Aeronautical Charting Forum 15-02 Reston, VA

AERONAUTICAL CHARTING FORUM (ACF)
MEETING 15-02 October 27, 2015
HOST: United States Geological Survey (USGS)
12201 Sunrise Valley Drive
RESTON, VA 20192

INSTRUMENT PROCEDURES GROUP (IPG) AGENDA

Figure 2a – MOONY3 SID SJC – Current:

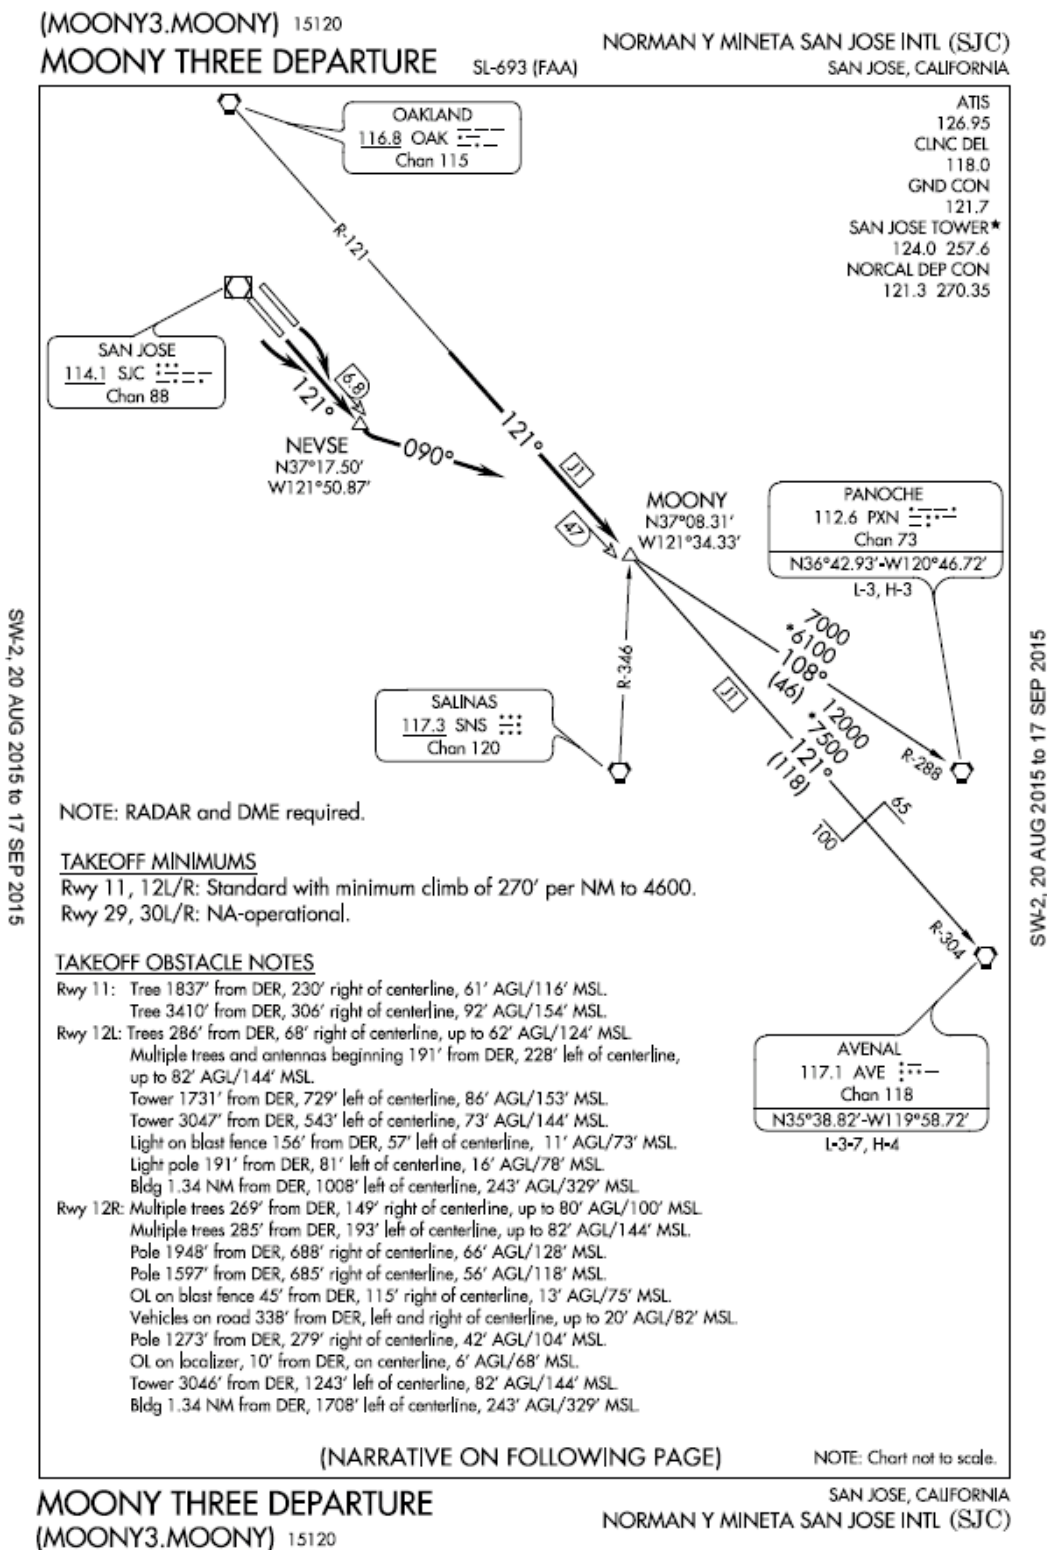
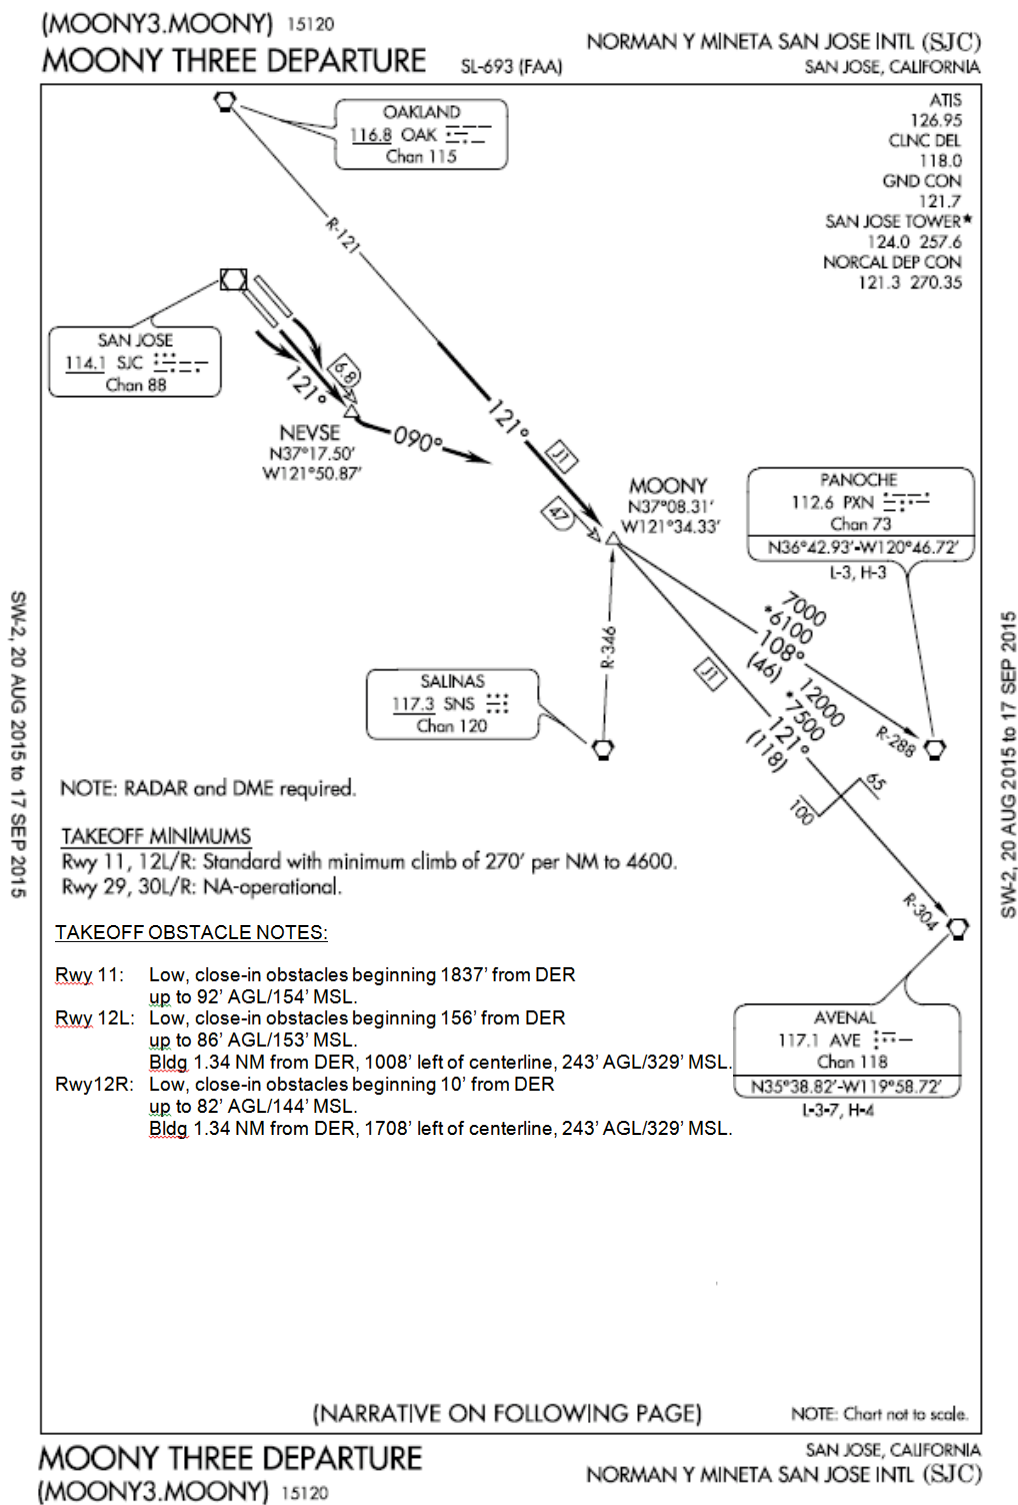
NBAA, with the support of other Industry partners, recommends that Order 8260.46 be amended to remove the requirement to publish the location of each individual or group of low, close in obstacles on SIDs and ODPs. In place of this requirement, we recommend that the “Takeoff Obstacle Notes” sections for the applicable 8260 Forms be changed to publish when low, close-in obstacles that are identified for a departure runway, document the existence of these obstacles along with the height of highest of these obstacles and the distance of the closest obstacle from the DER, as shown below:

Figure 1 depicts the current ODP entry for St. Cloud MN (STC) and the proposed change to the depiction of low, close-in obstacles. Figures 2a and 2b depict the current MOONY3 SID at San Jose, CA (SJC) and this chart with the proposed change.

In addition to reducing the complexity of the obstacle notes, attention is drawn to the obstacle(s) that must be visually avoided when using the higher than standard takeoff minimums in lieu of a higher than standard climb gradient (obstacle highlighted in red on the STC example – for reference in this document only - we are not suggesting red be used for publication). The revised note regarding low, close-in obstacles still furnishes the pilot with sufficient information for planning purposes to aid the pilot in vertically avoiding these obstacles.

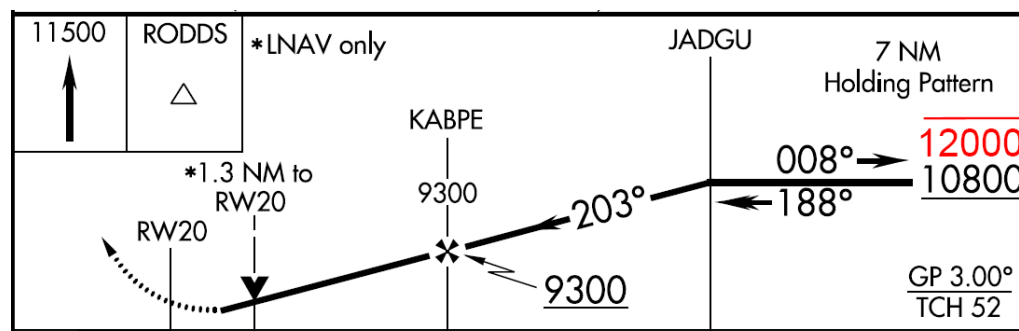
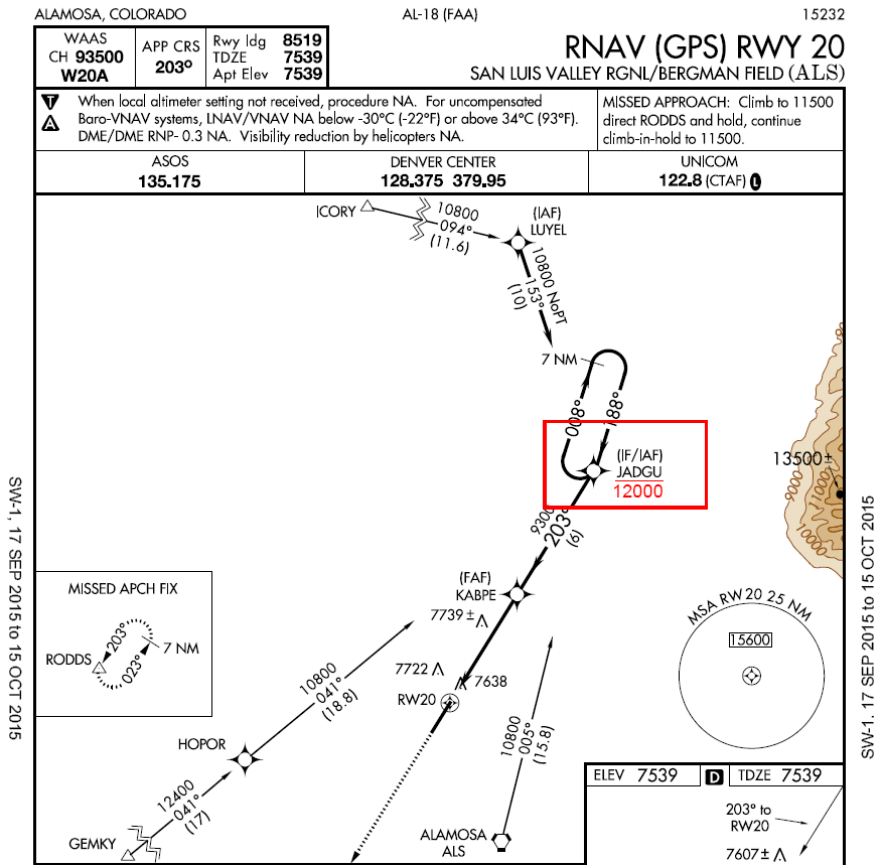
NBAA proposes that the same charting requirement applicable to a procedure turn when the 10,000' and below template is used, which is to chart a maximum "at or below" altitude at the IAF, be applied to a HILPT when a maximum holding altitude is specified on the 8260-2 Form. If this maximum holding altitude is specified for ATC-purposes, then this maximum altitude need not be published on the procedure chart.

Using the Alamosa RNAV (GPS) Rwy 20 approach example, JADGU would have an "at or below" 12,000' MSL altitude limit depicted in the profile view, as shown below:

Alternatively, a window, "at or below" and "at or above" altitude can be charted in the profile view. We invite the assistance of the ACF to determine the preferred method:

Figure 1

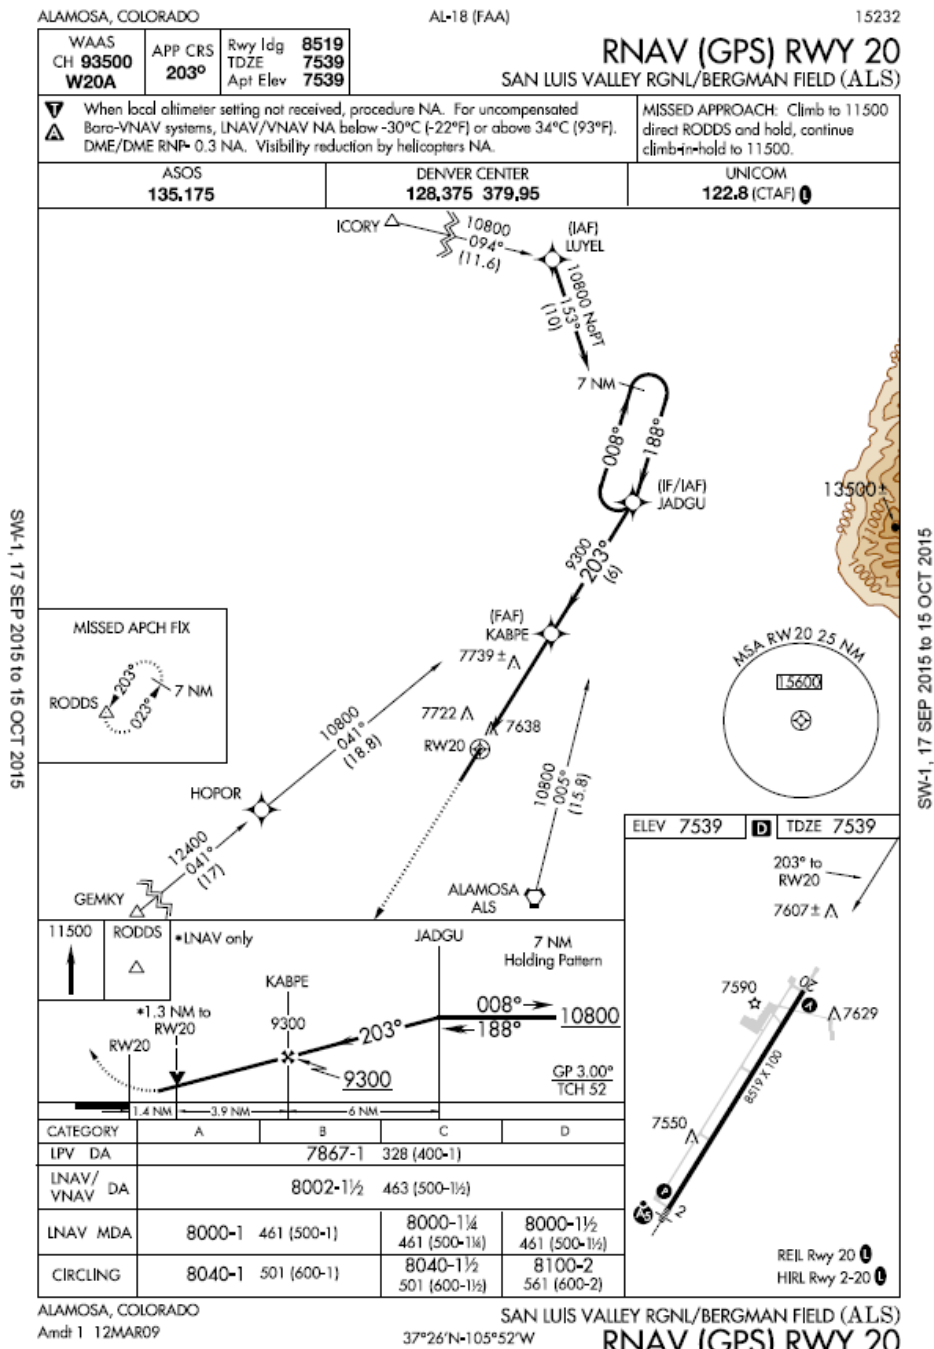
Figure 1 shows the RNAV (GPS) Rwy 20 approach at Alamosa, CO (KALS). The HILPT altitude is 10,800' MSL. Figure 2 shows the FAA 8260-2 Form for JADGU. The maximum holding altitude shown at JADGU is 12,000' MSL. Figure 2 depicts the protected airspace for the HILPT at JADGU based on the P10 pattern. Use of this pattern is required to allow the HILPT protected airspace to remain clear of the terrain to the east of Alamosa. A larger holding pattern would permit holding above 12,000' MSL. However, because of the terrain to the east, the use of a larger holding pattern template is not possible at this location.

Figure 4

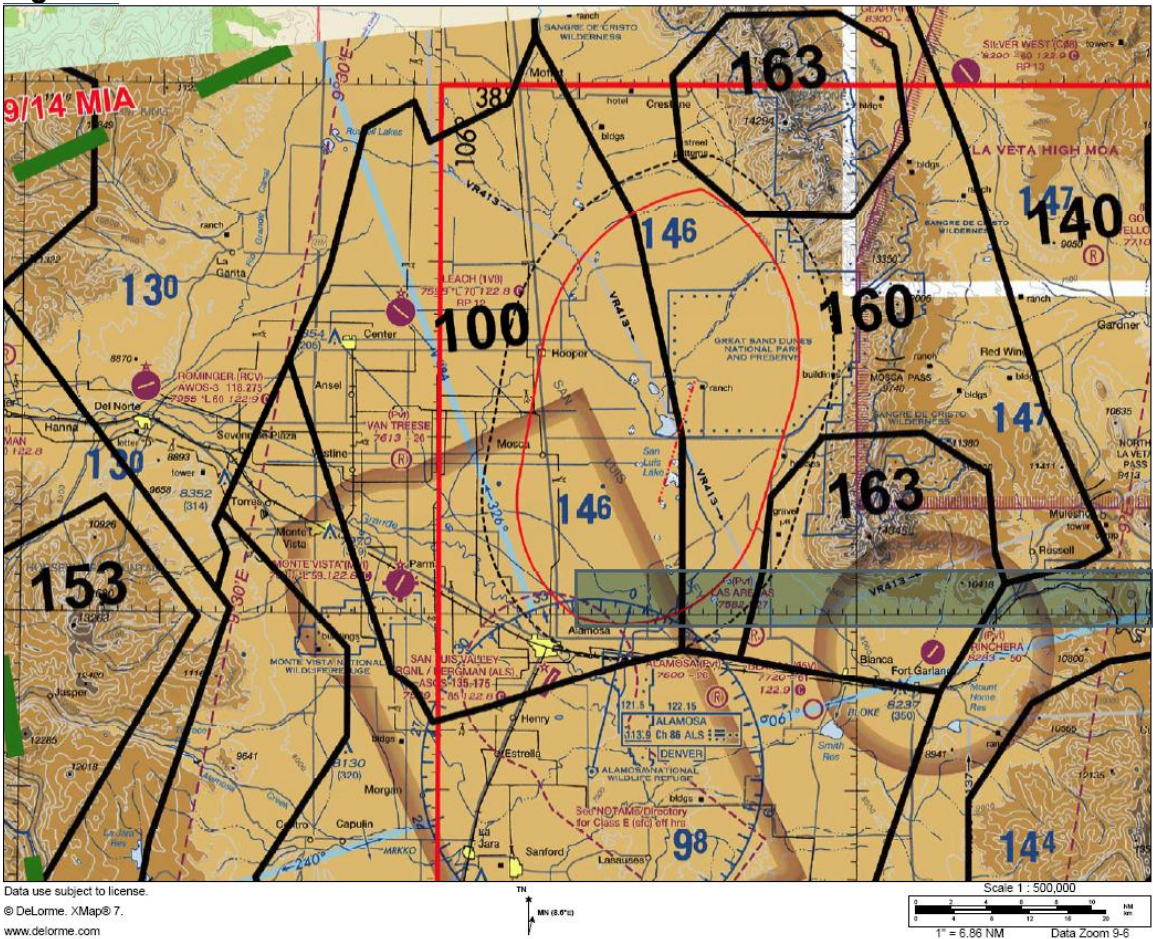
Figure 4 shows an overlay of the MIA altitudes in the vicinity of ALS. At most airports, ATC can bring the aircraft to the HILPT at or above the MVA or MIA and below any maximum holding altitude published on the 8260-2 Form. However, at Alamosa the MIAs east of the holding pattern protected airspace are at or above 16000' until just prior to JADGU. It is nearly impossible for ATC to clear an aircraft direct-to JADGU from the east at the 16000' MIA, and then descend the aircraft to cross JADGU at or below 12,000' as required by the holding pattern's maximum altitude prior to clearing it for the approach. This would require a descent of 4000 feet in little over 2 miles.
